Project: Metro Transit Phase 3A- Maintenance and Driver Facility

Contract No.: 8981
Enactment No.: RES-21-00422
Dollar Amount: 9,412,947.00

04/08/21 BID SET
 05/13/21 ADDENDUM #2

S-101A

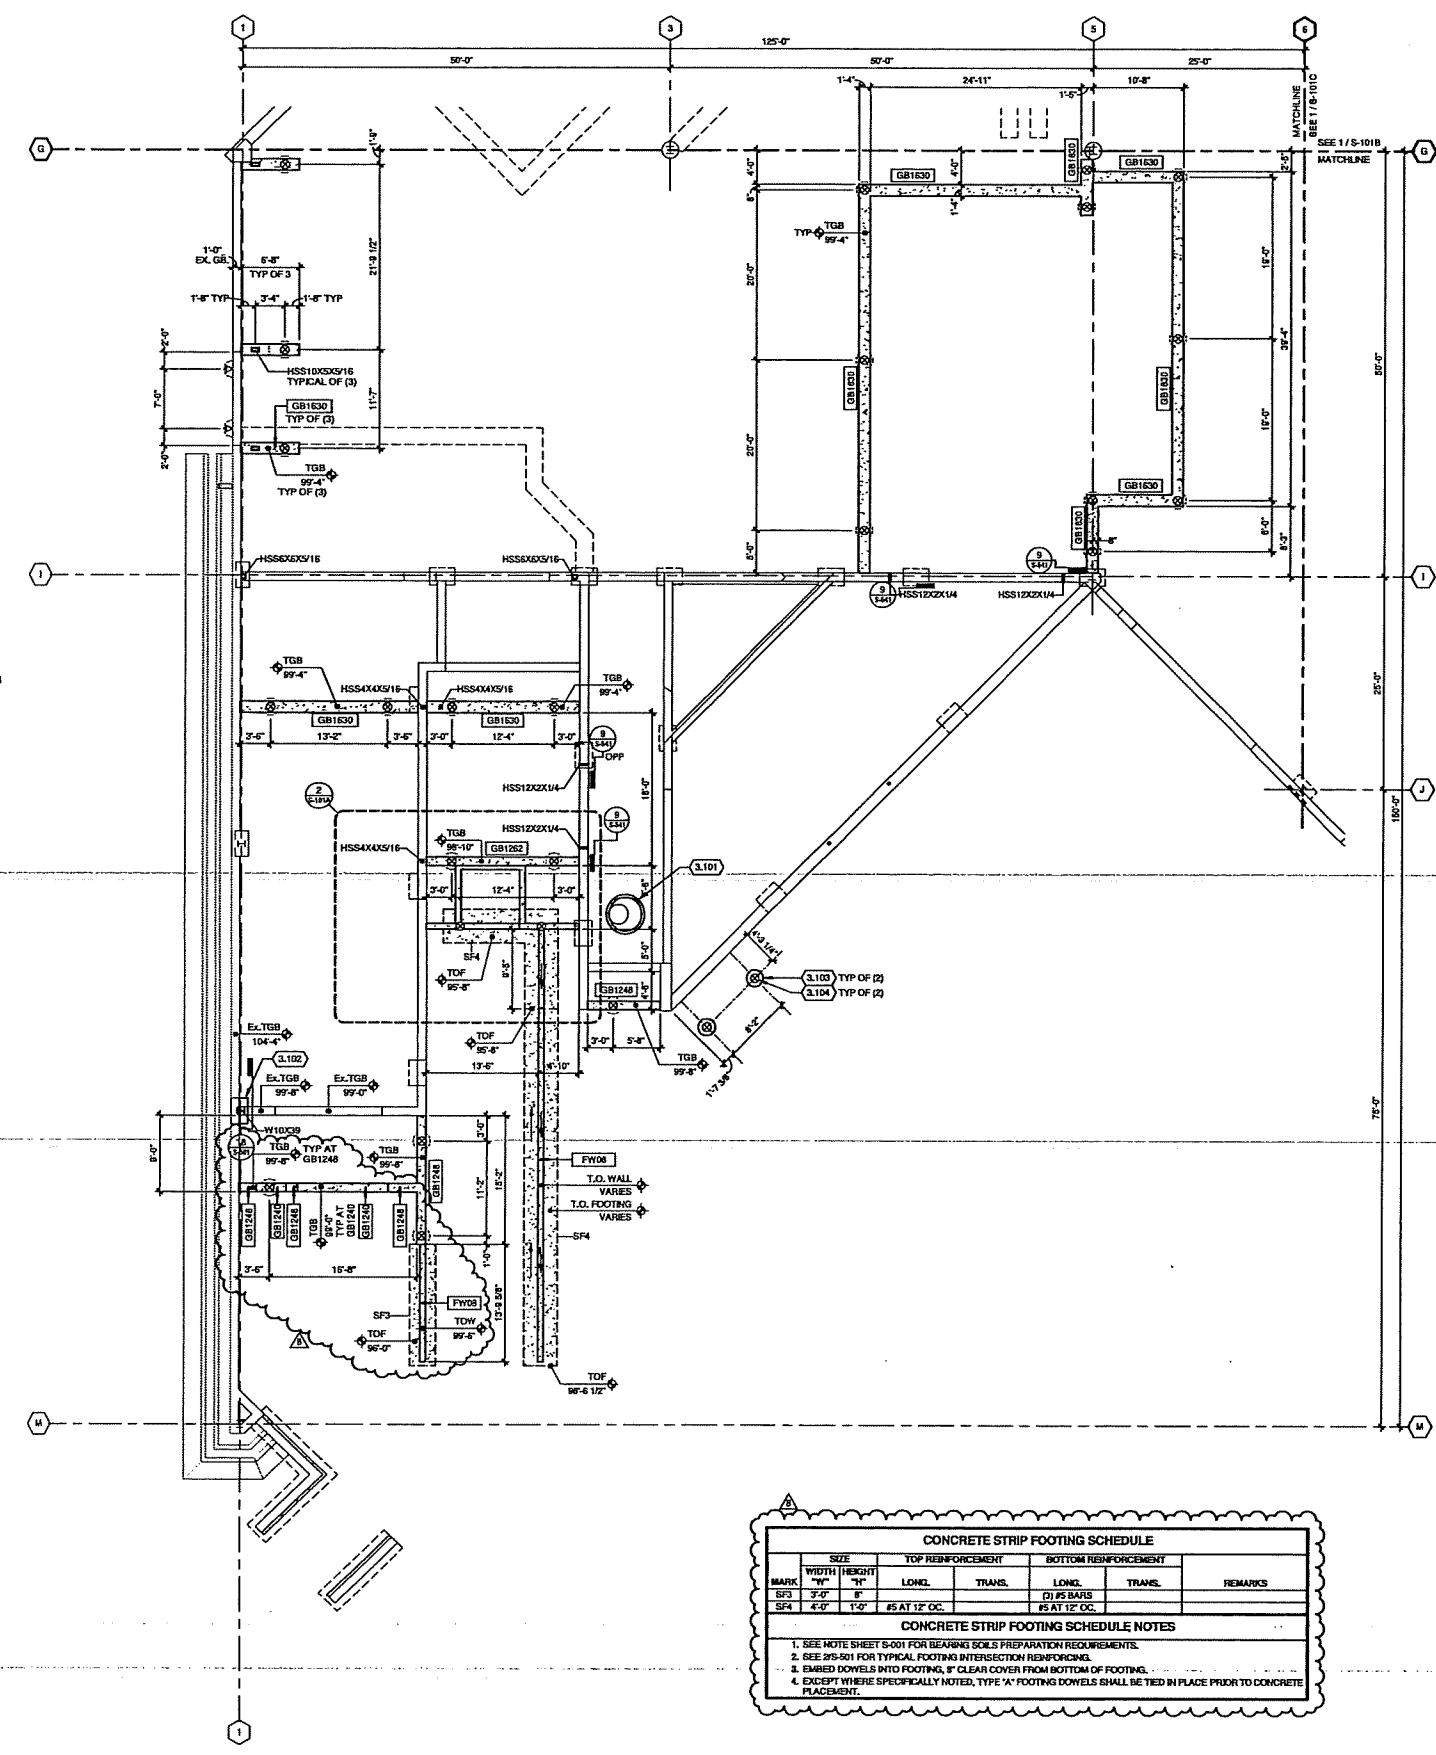
- iv. Drawing S-101A (attached); Strip footing schedule added, foundation added at end of truck dock.
- v. Drawing S-101B (attached); Added foundation for electrical room.

AD101A

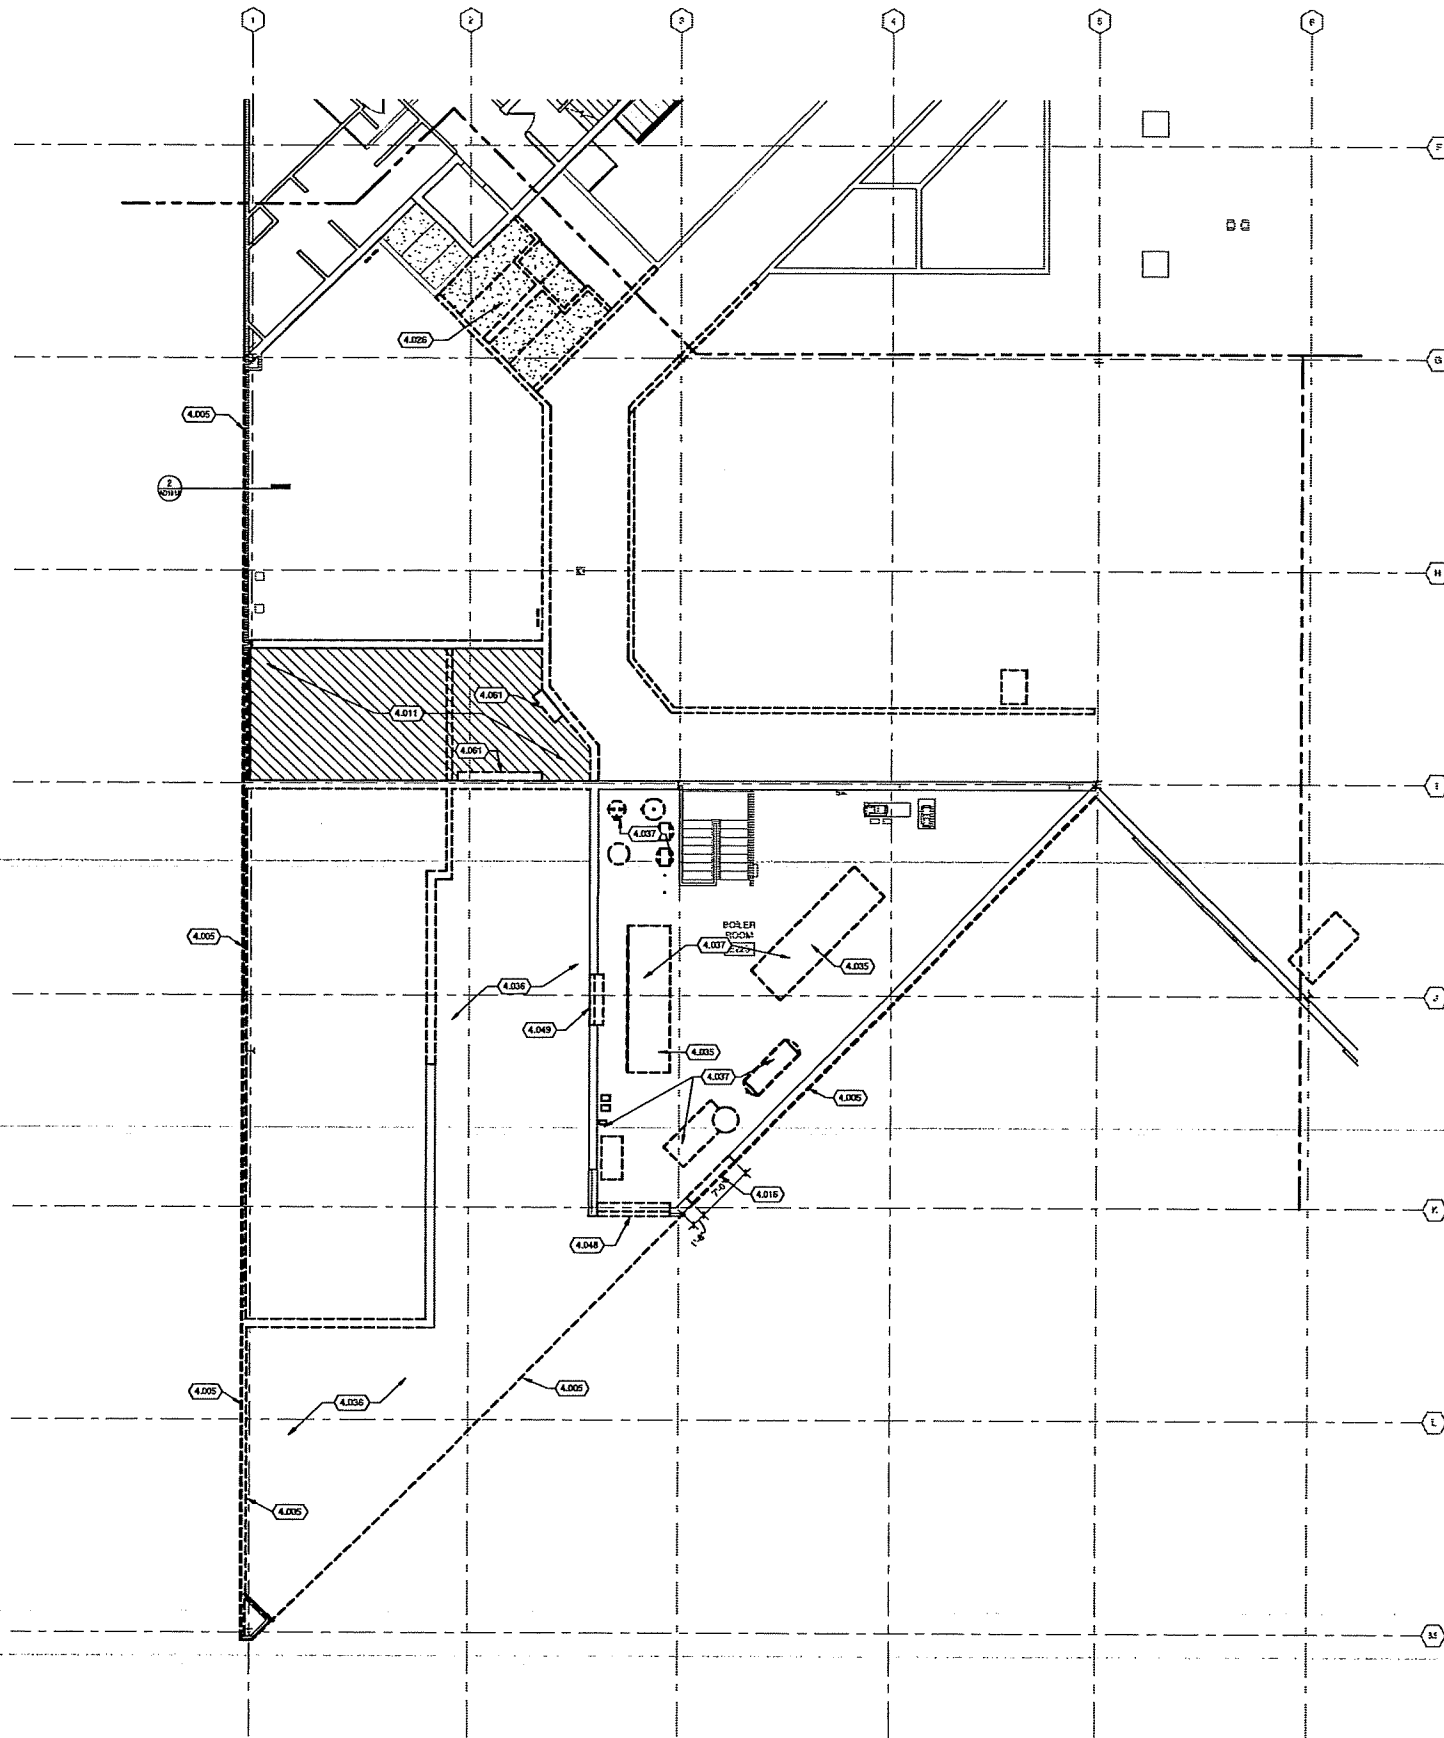
- i. Drawing AD101A (attached)
 - Room E135, add overhead crane demo and keynote.
 - Add Demo Keynote 4.062.
- ii. Drawing AD102A (attached)
 - Revise keynote 4.036.
- iii. Drawing A-602 (NOT attached), Door Type FC, add to the title “High Speed Rubber Roll-up Doors”
- iv. Add sheet A-801 (attached) Signage Plan and Types

QD101A

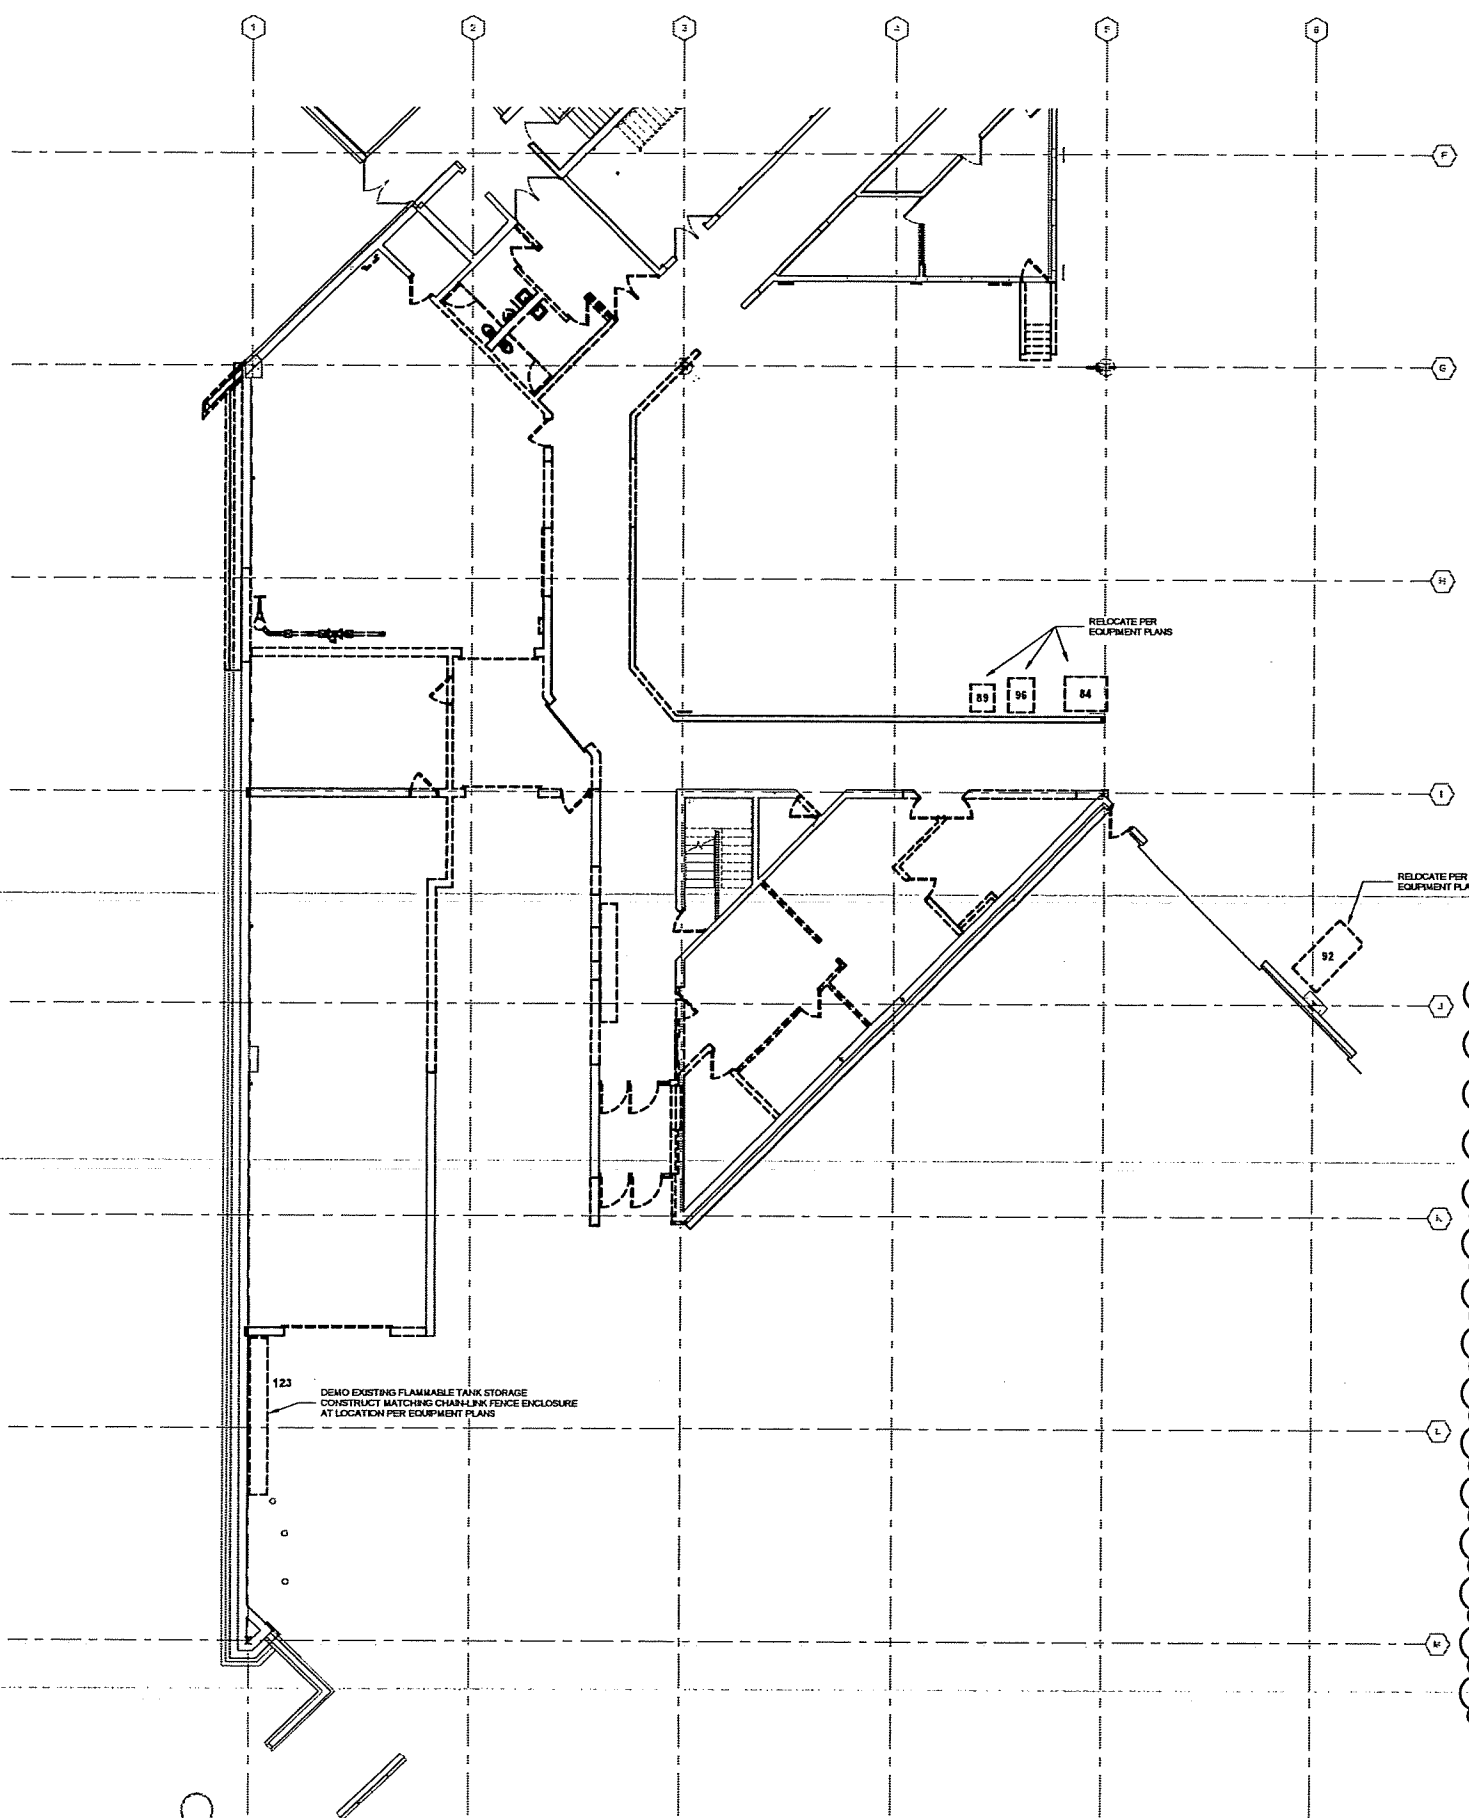
- i. Drawings QD101A, QD101C, QD101D, Q101A, Q101C, Q101D, Q101F & Q401 (attached)
 - Revise Equipment Schedule as shown.

PD131D

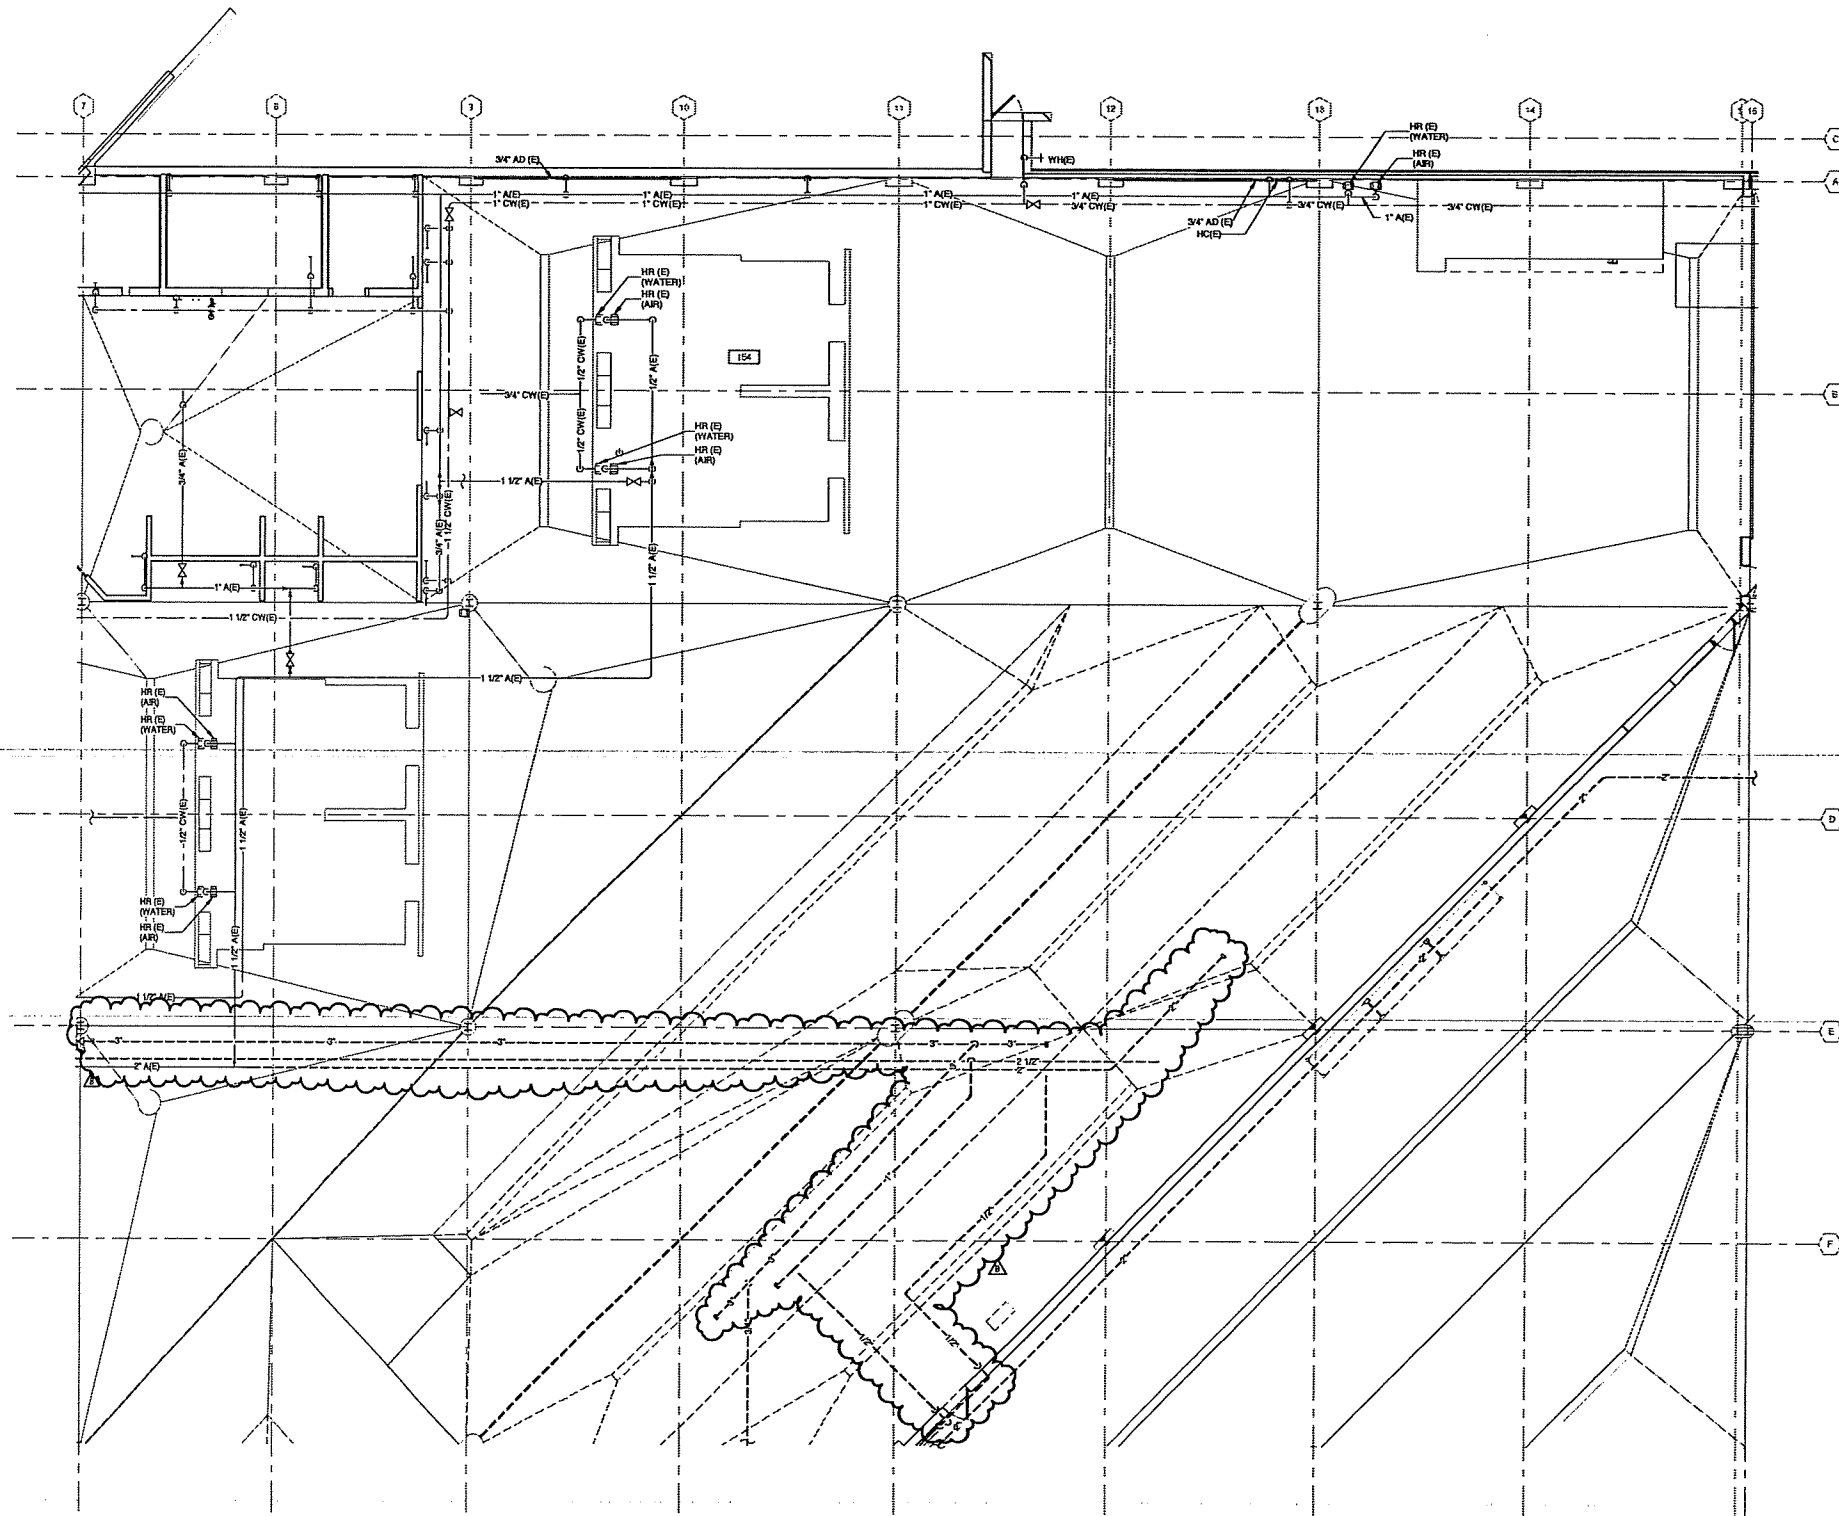
- i. Drawing PD131D (attached); Added additional compressed air and water supply pipe demolition.
- ii. Drawing P-100A (attached); Provide underground plumbing for future vending in Greeting 1112.
- iii. Drawing P-101A (attached); Provide aboveground plumbing for future vending in Greeting 1112.
- iv. Drawing P-131A (attached); Provide supply plumbing for future vending in Greeting 1112
- v. Drawing P-131D (attached);
 - Added new pipe connection to for existing compressed air and supply pipe lines.
 - Re-routed ESEW-1 piping plan south of the door.
 - Added new keyed note 6.158.
- vi. Drawing P-131F (attached); Provided additional Hose Reels for air and water, additional air drops.
- vii. Drawing P-431 (attached); Piping changes on Detail 3 and 4.
